Vulcan South EA Application

Supporting information and responses to the
Department of Environment and Science
Information Request relating to surface water

Vitrinite Pty Ltd
1571-20-D2, 14 March 2023

Figure 2.1 - Updated Stage 2 (Year 2026) Vulcan Main mining area conceptual drainage plan

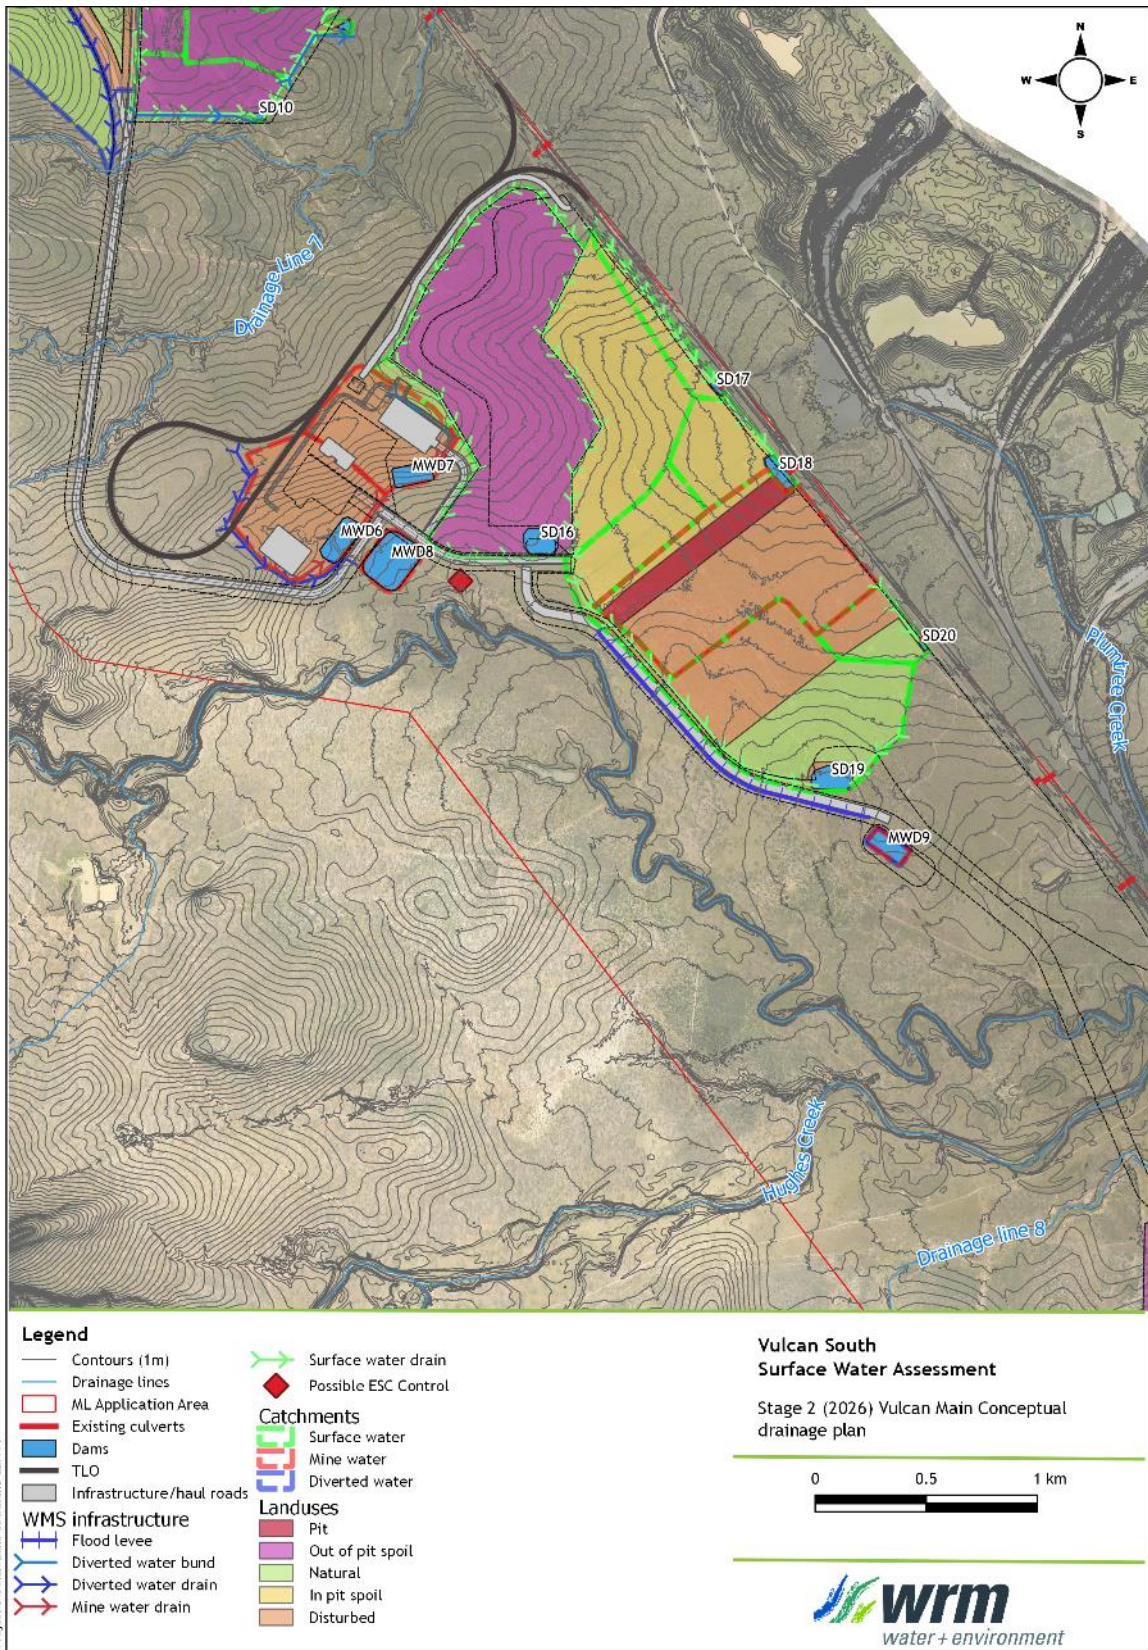
Figure 2.1 shows the updated conceptual drainage plan for the Stage 2 Vulcan Main mining area (Figure 1.6 of the Vulcan South SWA report), which amended an incorrectly shown surface water catchment boundary.
